Estero Land Development Code January 19, 2021

Addendum of Recommended Changes

63. A.1 Four and Six-Lane Arterial Roads

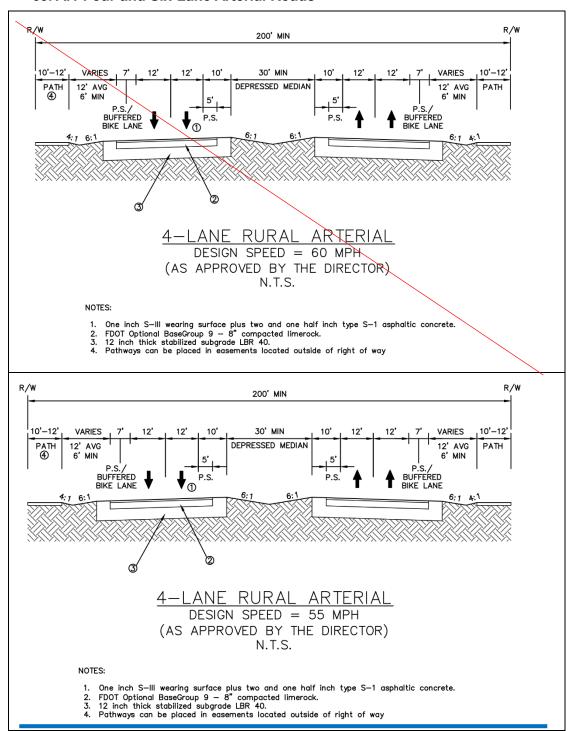
Changes to Appendix D on the following pages are technical in nature and recommended by Village staff
